ATTACHMENT 2

CONSOLIDATED SET OF PROPOSED TECHNICAL SPECIFICATION CHANGES

Incorporates changes associated with VEPCO's letters of  
November 2 and 30, 1984; April 12 and 17, 1985, and this letter.

List of Proposed Revised Pages

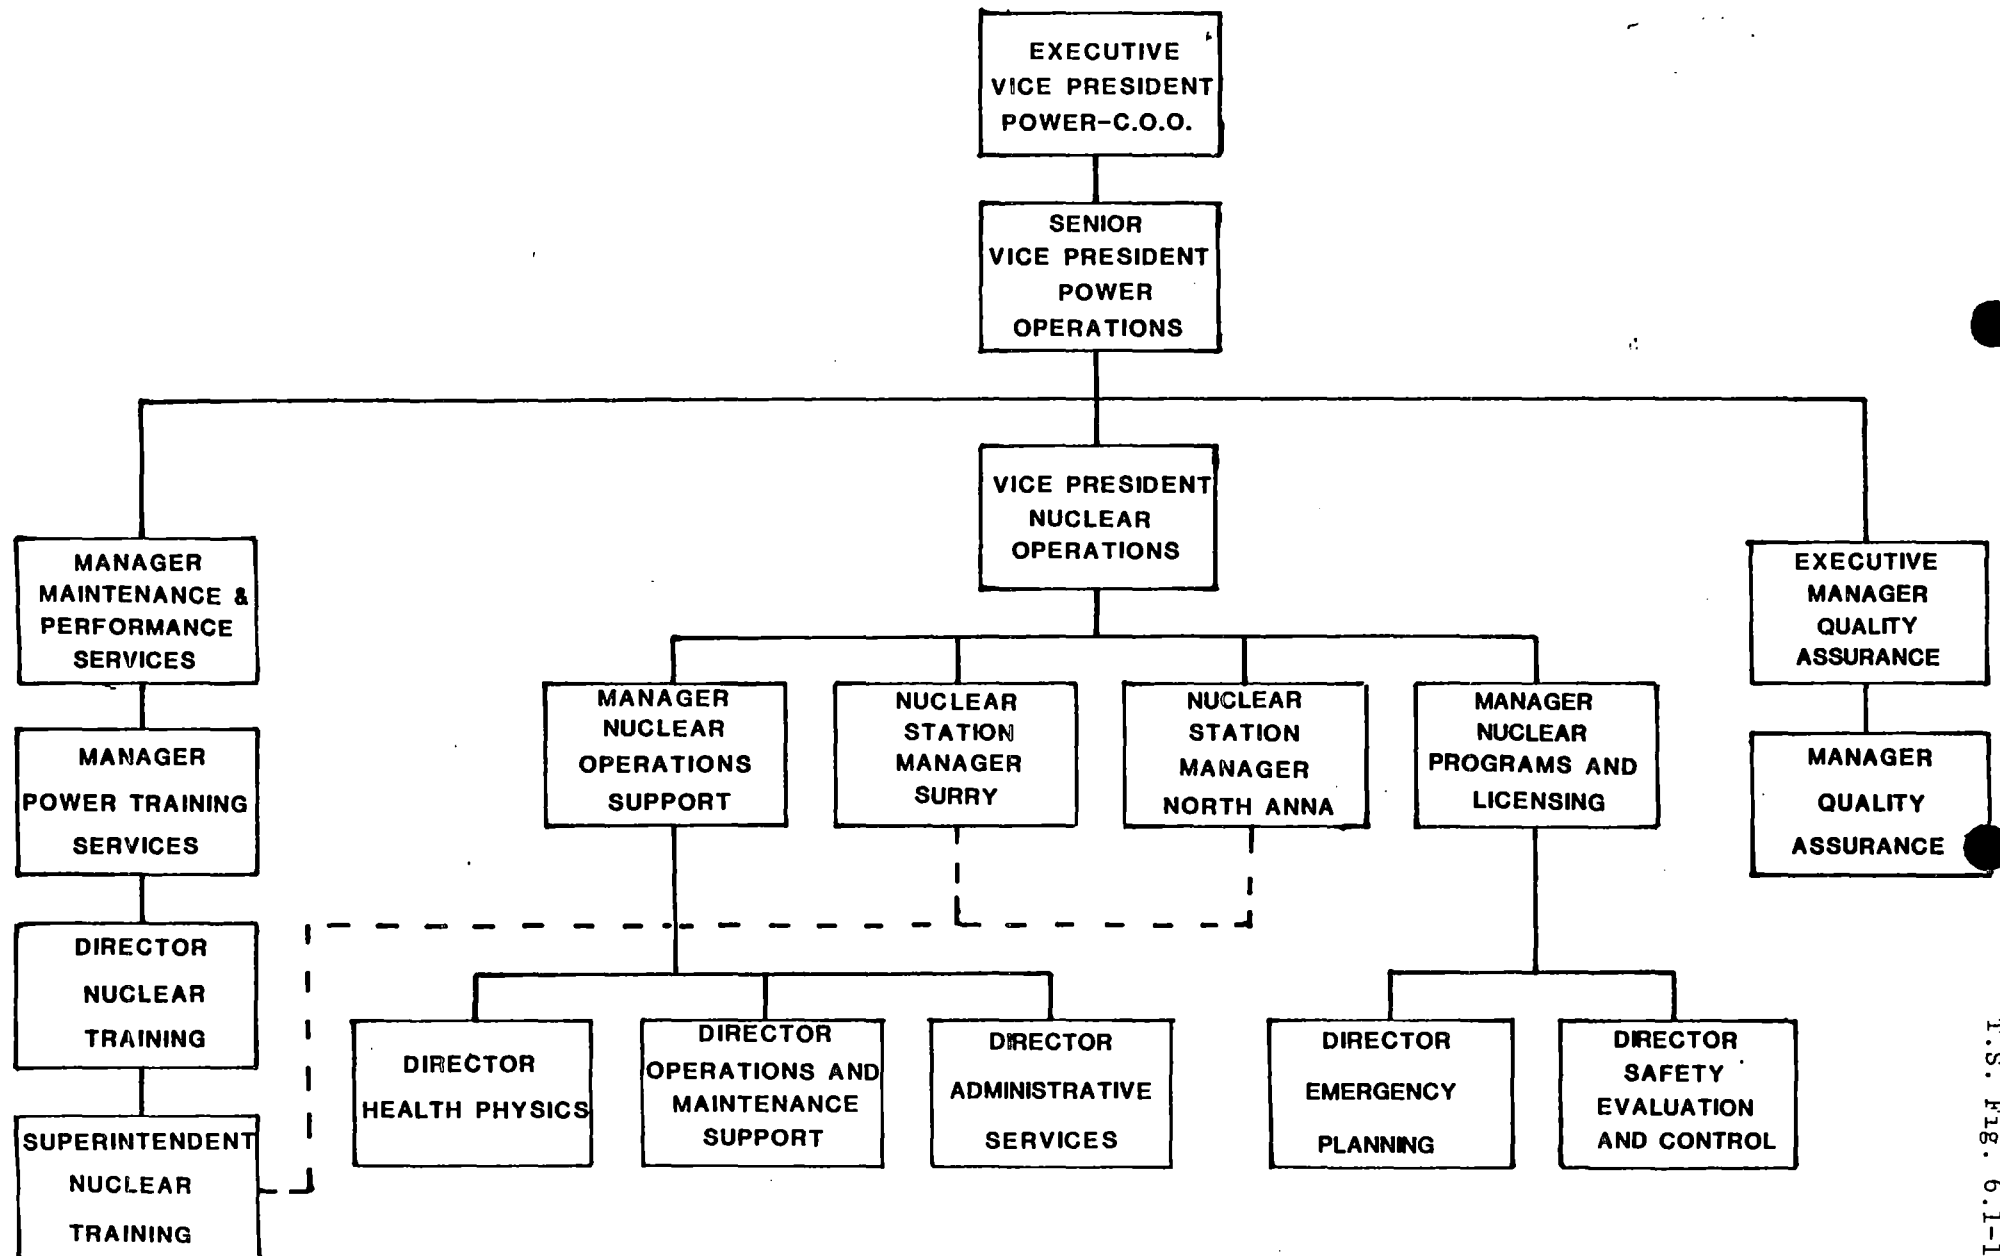
- 1. The off-site organization for facility management and technical support shall be as shown on TS Figure 6.1-1.
- B. The Station organization shall conform to the chart as shown on TS Figure 6.1-2.
